## STAFF REPORT

**Date:** May 26, 2015  
**To:** Bryan H. Montgomery, City Manager  
**From:** Kenneth W. Strelo, Senior Planner  
**SUBJECT:** Prescott at Cypress Grove Design Review (DR 03-15)

This is a request by Candace Hatch of DeNova Homes for design review approval of house plans and architecture, and a development plan (neighborhood plotting plan) for 40 entitled lots located within the Cypress Grove subdivision, specifically subdivisions 9080 and 9391, north of Ironhouse Elementary School and Delta Vista Middle School (4901 Frank Hengel Way) off of East Cypress Road and Frank Hengel Way. The site is zoned P-1 (Planned Development) District. Portion of APN 037-192-024.

**SECOND FLOOR PLAN (1284 S.F., 2402 TOTAL S.F.) 1/4"**

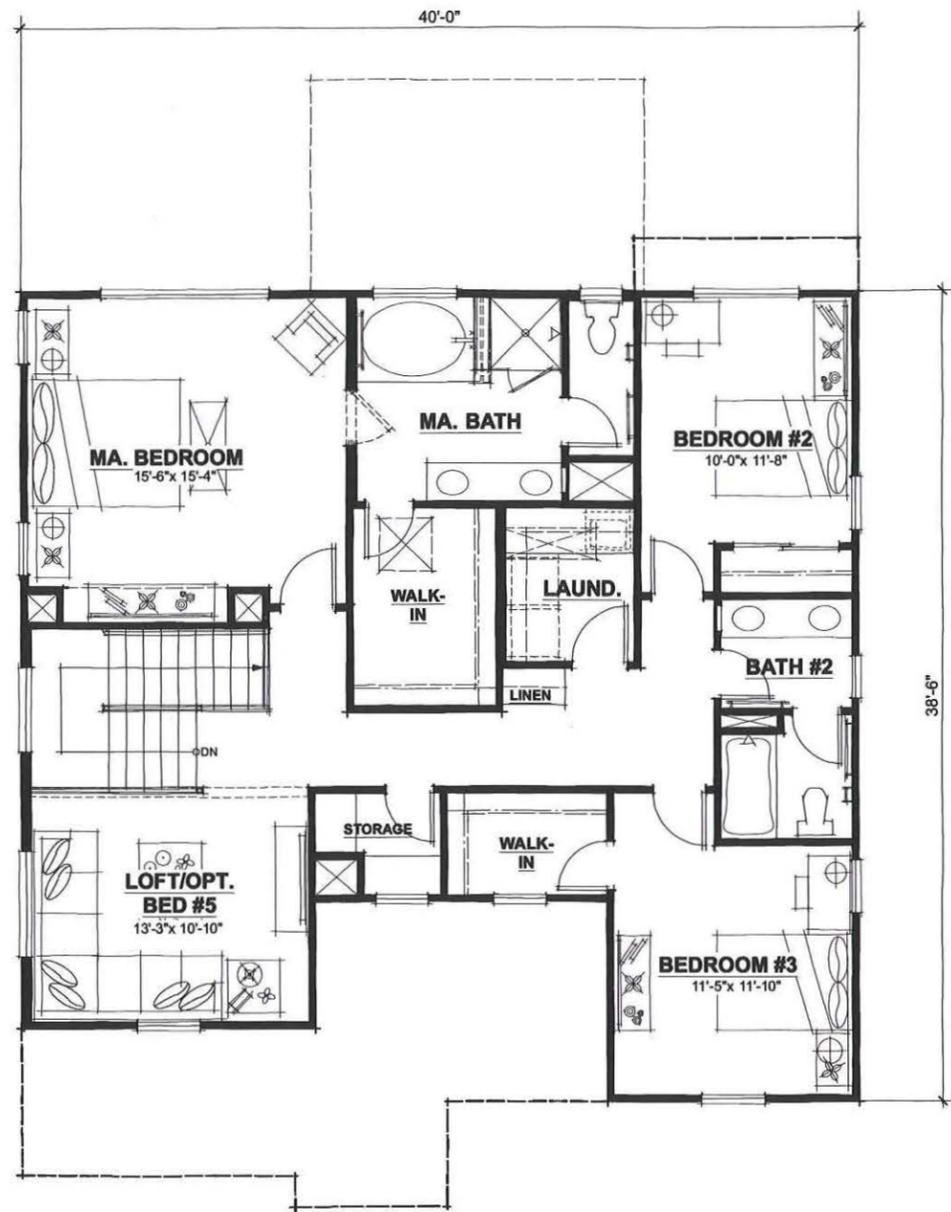
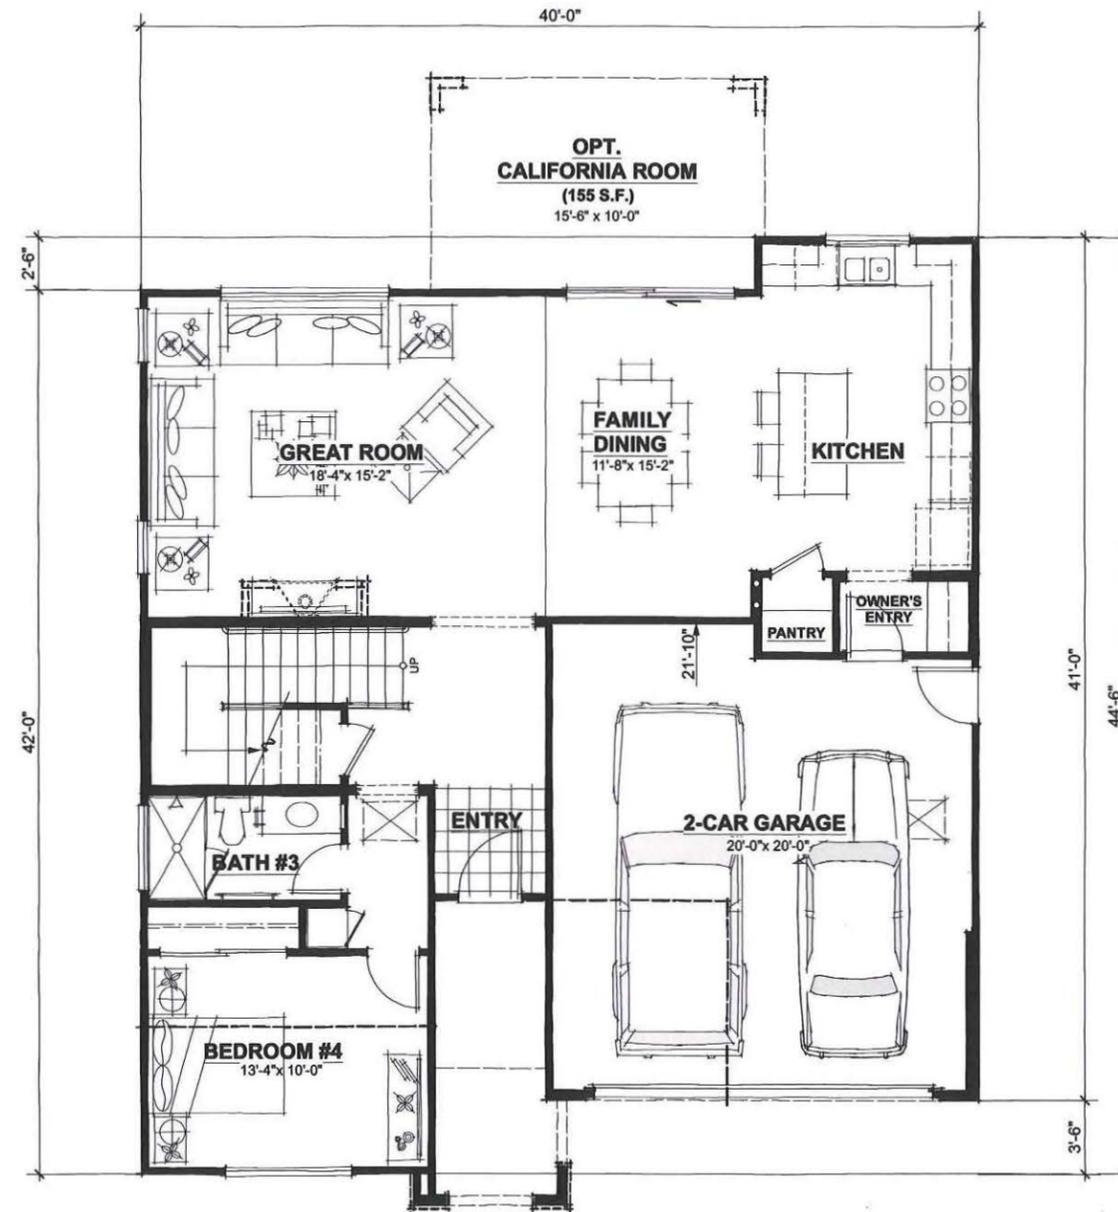
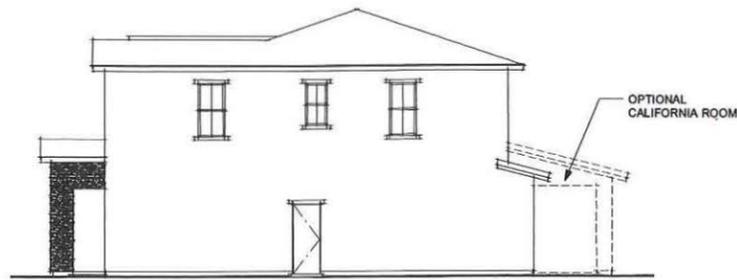
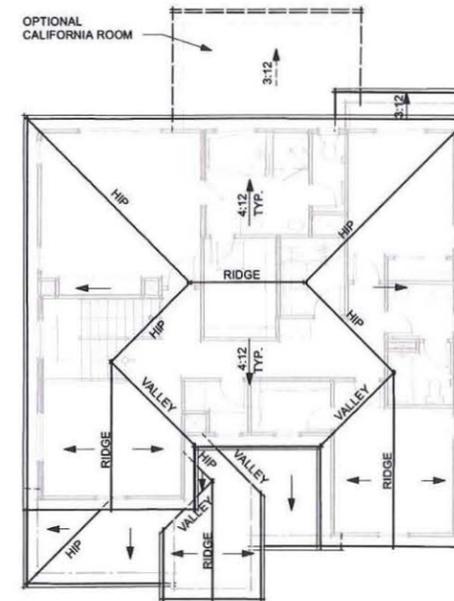
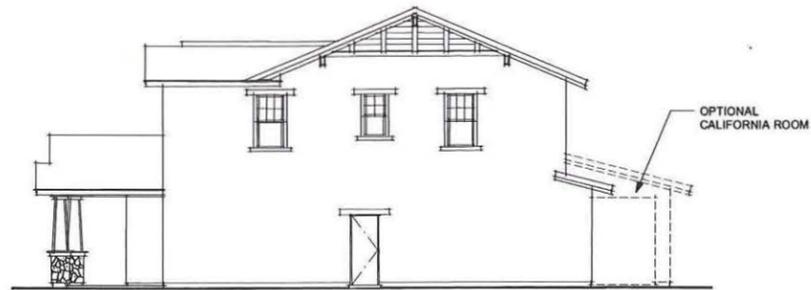
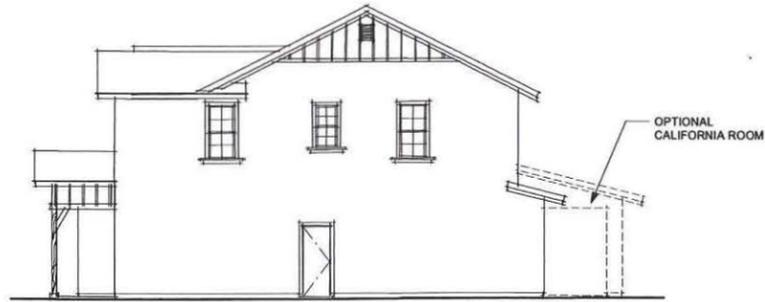
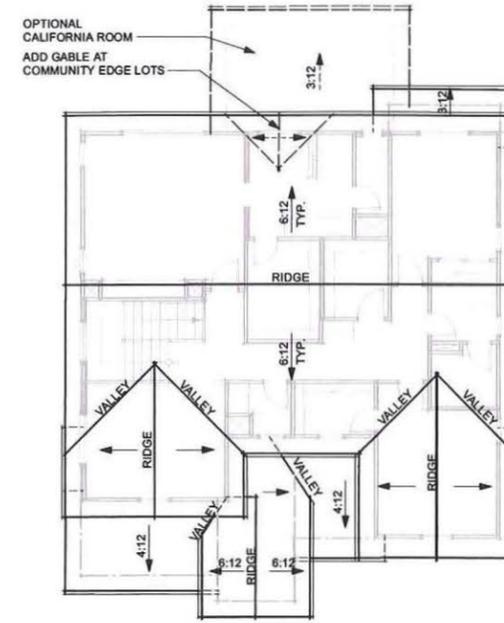
- Plan 2 and Plan 4 (Tuscan), and Plan 4 (Farmhouse) – Right elevation.
- Plan 2 (Craftsman and Farmhouse), and Plan 4 (Farmhouse) – Rear elevation window where gable, outlookers and shutters would otherwise be installed go for enhanced lots.
- Plan 2 (Craftsman and Farmhouse) – Right and left elevations.
- Plan 4 (Tuscan) – Right Elevation

11. The applicant shall add shutters to at least one window on the following second story elevations:
  - Plan 2 and Plan 4 (Tuscan), and Plan 4 (Farmhouse) – Right elevation;

- Plan 2 (Craftsman and Farmhouse), and Plan 4 (Farmhouse) – Rear elevation window where gable, outlookers and shutters would otherwise be installed go for enhanced lots;

- Plan 2 (Craftsman and Farmhouse) – Right and left elevations; and
  - Plan 4 (Tuscan) – Right Elevation
12. The additional architectural element in the form of a rear elevation gable with enhancements proposed for “community edge lots” on the applicant’s plans and shown on Plans 2 and 4 of the Craftsman and Farmhouse architectural types only shall be required on the applicable homes on Lots 1, 27, 28, and 31-40, as indicated on the Development Plan.

**DeNova Homes**  
**PRESCOTT**  
**DEVELOPMENT PLAN**

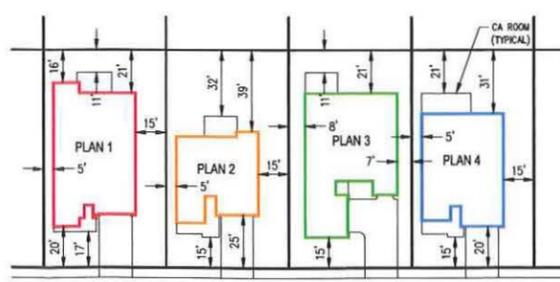
story homes (Plan 1), which makes up 10 of the 40 lots. Only one of the five corner lots is proposed with the one-story home, which does not sufficiently implement the 50% requirement. In order to comply, the applicant would need to replace two of the four two-story corner lots with the one-story home. Since, the Development Plan currently shows 25% of the homes as one-story, the applicant could switch out two of the non-corner one-story homes with two of the two-story corner homes. This switch which would maintain the same overall balance of homes types, and satisfy the corner lot requirement.

shown on Plans 2 and 4 on the Craftsman and Farmhouse architectural types only. Staff recommends the lots for which this enhancement will be present include: Lots 1, 27, 28, and 31-40. This would include corner lots adjacent to Picasso Drive and those lots backing up to Escher Circle or the existing park. If applied to the proposed Development Plan and applicable house plans, the enhancement would only be required on lots 27, 32, 35, 36, 38 and 40. A couple more of those lots could apply if they were proposed as single-story and switched out with a Plan 2 or 4 on a corner to satisfy the corner lot single-story requirement. At most, it appears 8 lots could be impacted, but probably less since the Tuscan architectural type is not affected.

10. In order to provide at least 50% of the corner lots with one-story homes, the applicant shall replace two of the four two-story corner lots with the one-story home.
